STAFF-DR-03-001

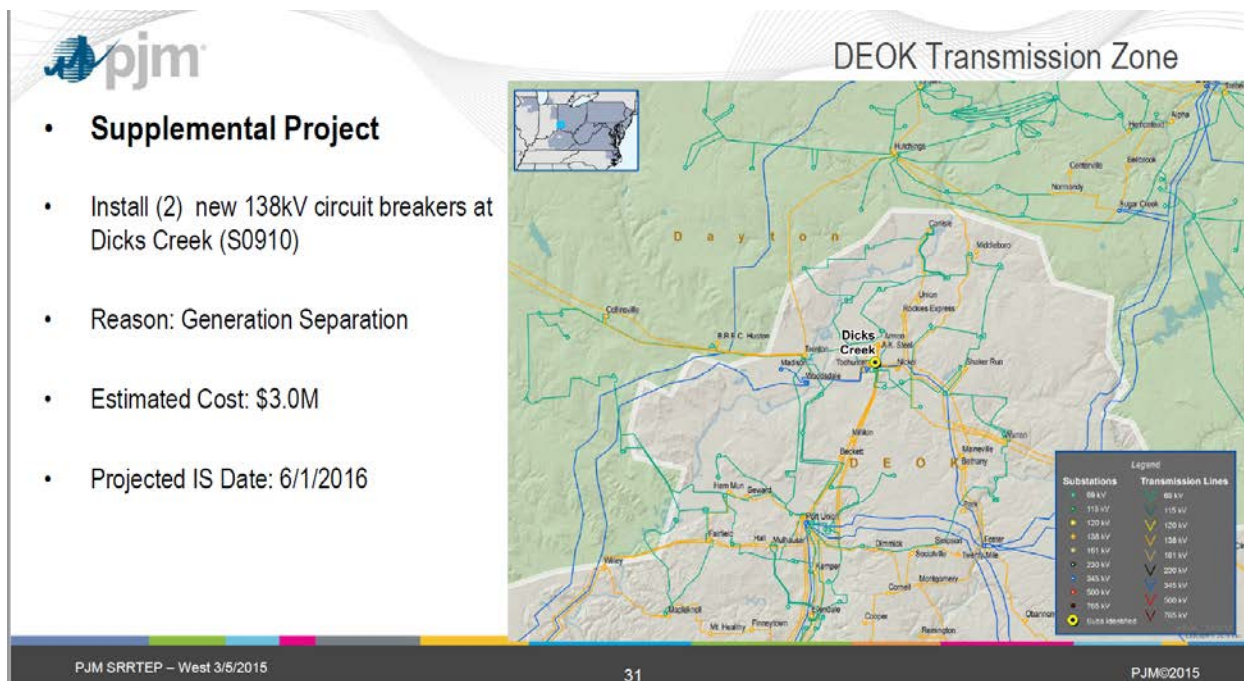
1. Please send us:
 - a) a switching diagram and
 - b) the latest S0910 presentation slides at the PJM RTEP.
2. Please explain why the 138kV lines need to be reconductored.

1.(b) The PJM slides are found on the web here: <https://www.pjm.com/-/media/committees-groups/committees/srrtep-w/20150305/20150305-reliability-analysis-update.ashx>; at page 31. For convenience, a screenshot is reproduced below.
